CITY OF HOBART

Planning Authority Committee Meeting
Open Portion
Wednesday, 6 May 2026
at 4.00pm
Council Chamber, Town Hall

7.2.1 4 South Street, Battery Point - Partial Demolition, Alterations and Extension	88
8. REPORTS	190
8.1 Delegated Decision Report (Planning)	190
8.2 Planning - Advertised Applications Report	194

7.1.1 80 KING STREET, SANDY BAY - PARTIAL DEMOLITION, ALTERATIONS, EXTENSION AND CHANGE OF USE TO MULTIPLE DWELLING (ONE EXISTING AND ONE NEW) PLN-HOB-2024-0478 - FILE REF: F26/24525

Figure 2 – Officer Indicative Illustration based on submitted plans showing proposed and an alternative one and a half design response.

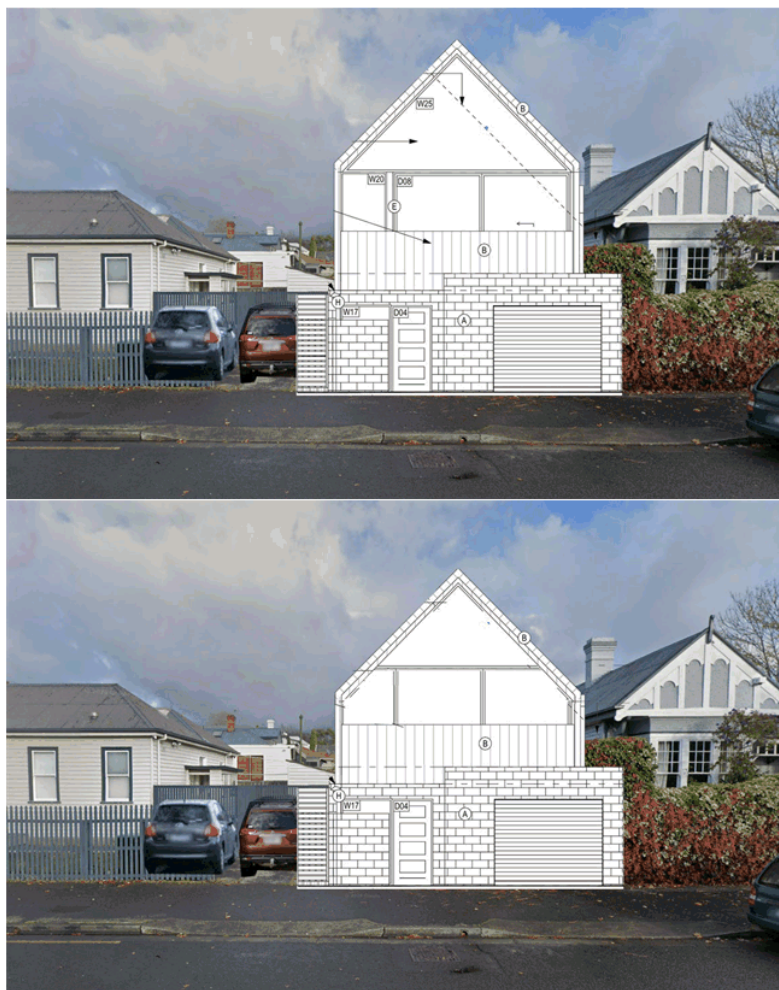
In this instance, to comply with the policy requirement to retain a coherent and consistent built form within the Precinct, this narrowness of the plot should to a degree provide a guide as to the height in which development is in proportion to its width and therefore have the ability to sit comfortably within the streetscape.

The proposed new dwelling, by reason of its height, design and façade treatment would have a detrimental impact upon those features which contribute to the historic cultural significance of the Upper Sandy Bay Heritage Precinct (SB2) as set out in table E.13.2 of the Hobart Interim Planning Scheme 2015, contrary to E13.8 Development Standards for Heritage Precincts, in particular E13.8.2 – 'Buildings and Works other than Demolition' P1.

Figure 8: Extract of the proposed southern elevation showing the difference in height of the existing cottage side wall (left) and the proposed extension boundary wall (centre and right). Source: Applicant's documentation, Shurman Design, drawing A06, 'Elevations Proposed', 20.10.2025.

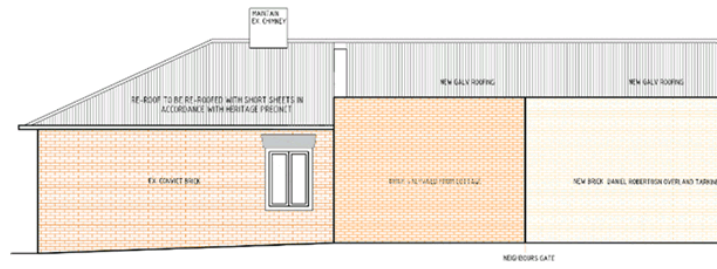
<p>6.8.6</p>	<p>The proposed addition to the side and rear will be visible from South Street. As such, the acceptable solution at clause C6.7.3 A1 is not met and the proposal relies upon assessment against the performance criteria at clause C6.7.3 P1.1.</p> <ul style="list-style-type: none"> (a) Relevant values identified in the statements of significance refer to the workers cottages, Colonial and Victorian Georgian buildings of the first phase of construction in Battery Point, and consistently detailed buildings of one and two storeys. The proposed extension does not alter the front of the building and its immediate street frontage contribution to the precinct is unaltered. The extension will be visible in relation to the front façade, however, and visible in the streetscape. The impact is mitigated by the reuse of existing bricks and the use of complementary colours, which would likely allow the proposed extension to site relatively comfortably within the immediate streetscape and not significantly detract from the interpretation of the precinct values. (b) The character and appearance of the surrounding area is generally typified by single storey Georgian conjoined workers cottages with occasional larger Georgian dwellings. The proposed works allow the existing conjoined dwellings to retain this presentation with an intervention that is evidently contemporary towards the rear. (c) While the overall ridge height of the proposed extension is no greater than the existing cottage, by continuing the ridge height across the entire length of the proposed rear addition, the height of the side addition and its impact is more evident. <p>This would be compounded by the wall to the southern boundary springing from above the existing eaves line, creating an awkward junction with the existing roof and increasing the visual prominence of the proposed extension in the streetscape.</p>

The overall height of the proposed southern wall as shown in the drawing A06 'Elevations Proposed' drawing by Shurman Design, dated 20.10.2025 is not approved. The addition is to connect to the existing southern wall below the eaves as indicated in the render on drawing A08 'Materials' by Shurman Design, dated 20.10.2025. The proposed southern wall is to be lowered correspondingly to align with this height.

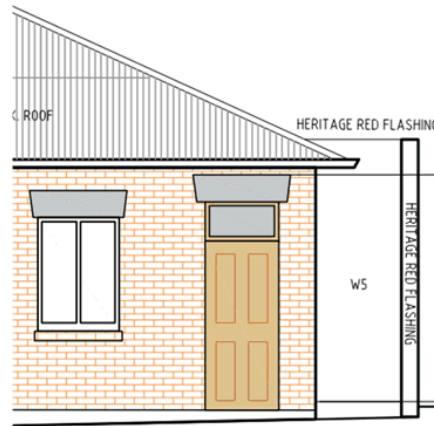
Figure 9: Extract of the proposed western elevation showing the difference in height of the existing cottage side boundary wall and the proposed extension boundary wall (labelled with 'heritage red flashing'). Source: Applicant's documentation, Shurman Design, drawing A06, 'Elevations Proposed', 20.10.2025.

SCALE: 1:100 @ A3
 DWG. No.: **A06**
 DRAWN: c.shurman DATE: 20.10.25

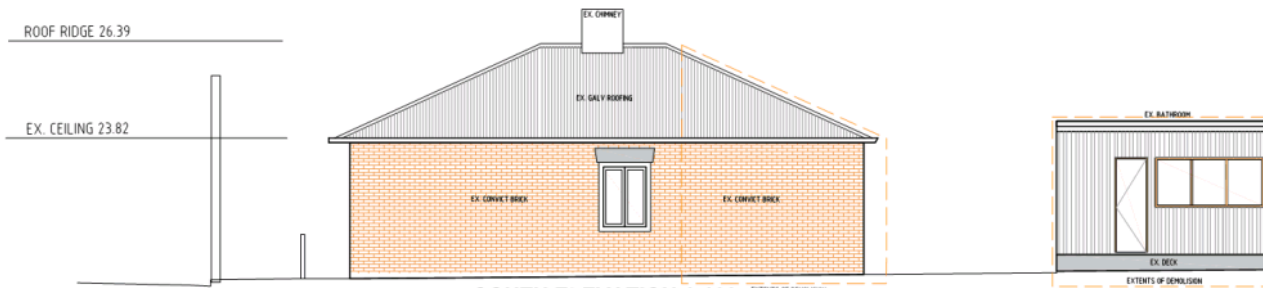
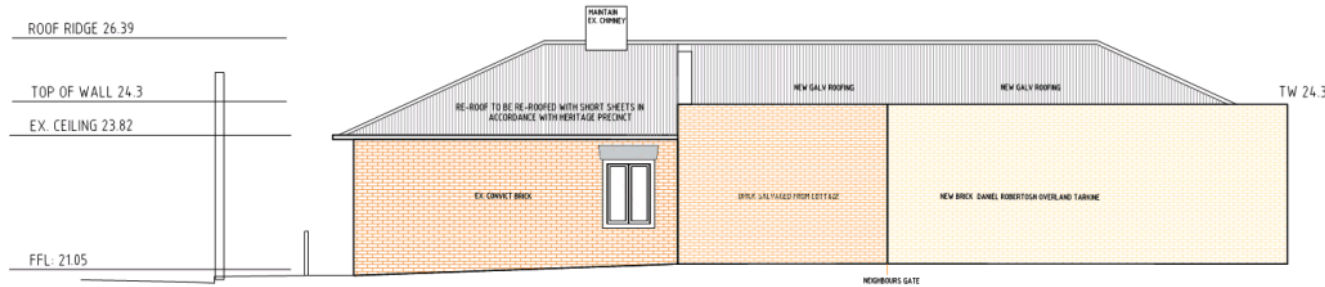
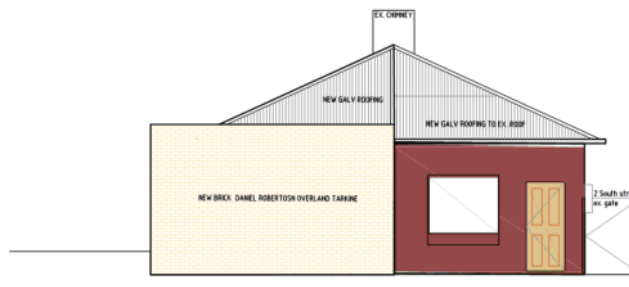
The overall height of the proposed southern wall as shown in the drawing A06 'Elevations Proposed' drawing by Shurman Design, dated 20.10.2025 is not approved. The addition is to connect to the existing southern wall below the eaves as indicated in the render on drawing A08 'Materials' by Shurman Design, dated 20.10.2025. The proposed southern wall is to be lowered correspondingly to align with this height.

HER 2 - The overall height of the proposed southern wall as shown in the drawing A06 'Elevations Proposed' drawing by Shurman Design, dated 20.10.2025 is not approved. The addition is to connect to the existing southern wall below the eaves as indicated in the render on drawing A08 'Materials' by Shurman Design, dated 20.10.2025. The proposed southern wall is to be lowered correspondingly to align with this height.

HER 1 - Partial demolition of the brick wall is to be undertaken with care to allow the brickwork to be salvaged for reuse on site in the new works as per the nominated materials, colours and finishes indicated in the elevations in drawing A06 'Elevations Proposed' by Shurman Design, dated 20.10.25.
